# TEN-T Priority Route Improvement Project, Donegal

# Phase 2, Option Selection Report Volume C2-Section 2 Non-Environmental Appendices

Appendix C2.5 – Section 2 Road Safety Audit Stage F – Part 2

Section 2: N56 / N13 Letterkenny to Manorcunningham

Location: Existing N13 west of Pluck Roundabout

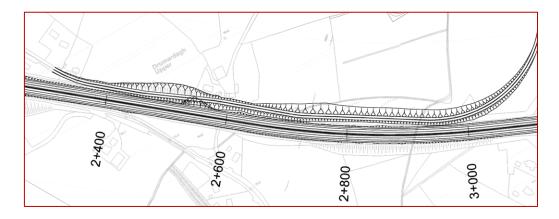
Summary: Drivers could be dazzled by lights of vehicles on adjacent road.

A realigned local road is located to the north of, and adjacent to, the existing N13 west of Pluck Roundabout (approximate Chainage 2,400 to 3,000).
